Proposed improvement to create safer routes to school than proposed TC8834/GA/02 scheme.

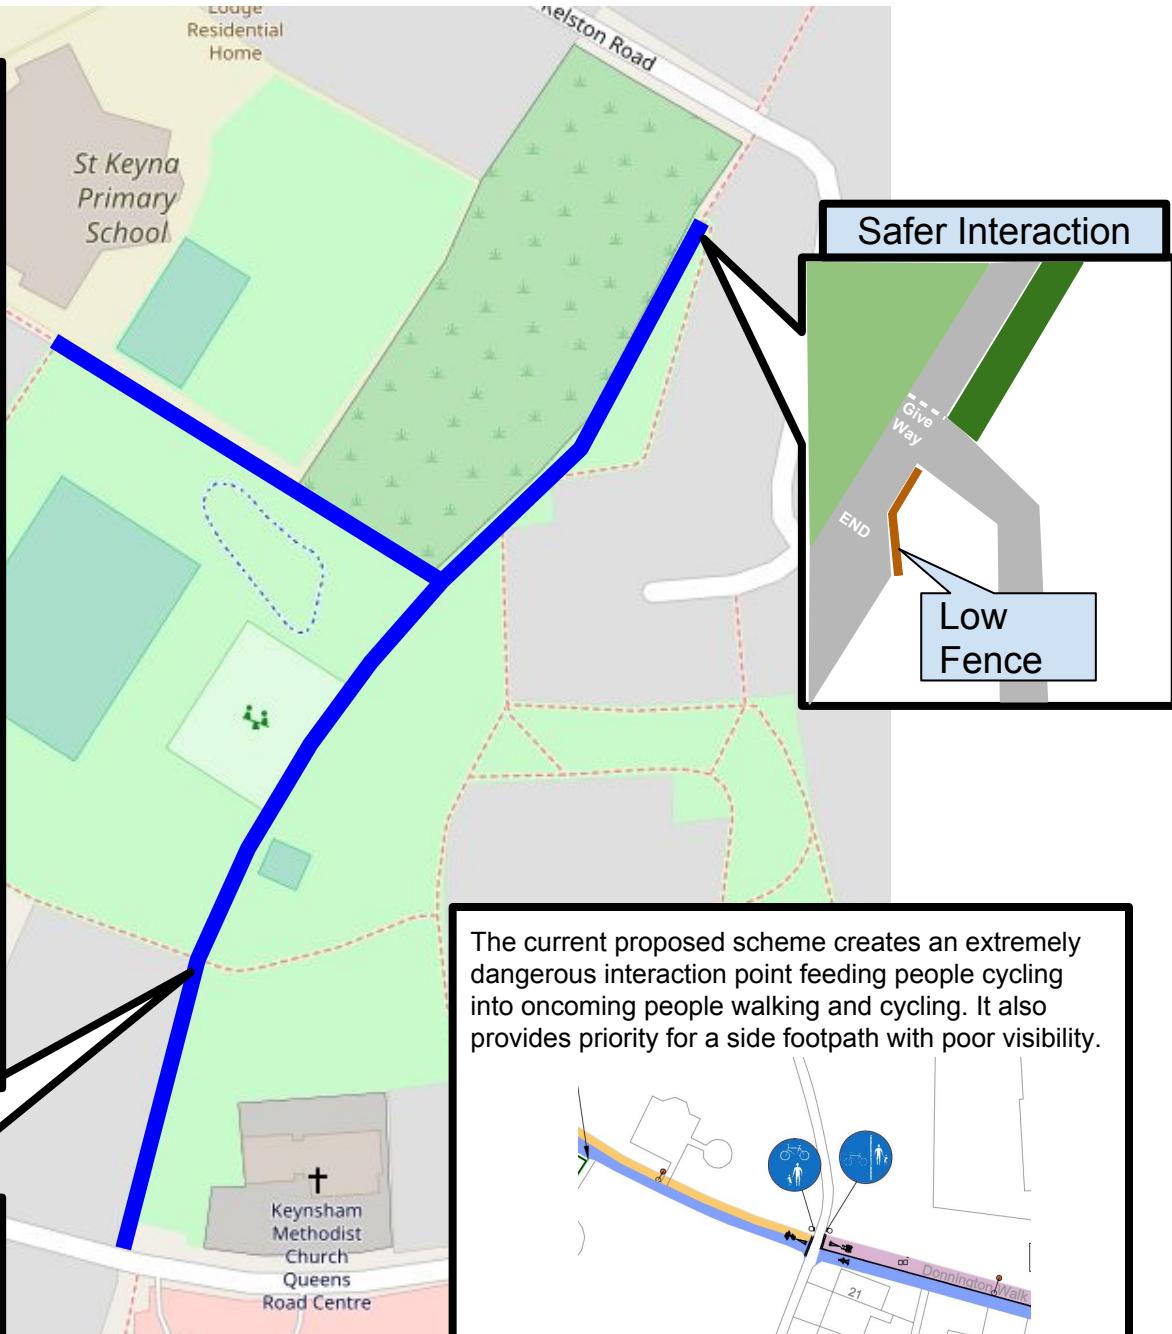
The scheme ends suddenly at the school junction failing to provide a good route from the north and connecting to the existing good wide path north of Kelston Road

The current proposed scheme creates an extremely dangerous interaction point feeding people cycling into oncoming people walking and cycling. It also provides priority for a side footpath with poor visibility.
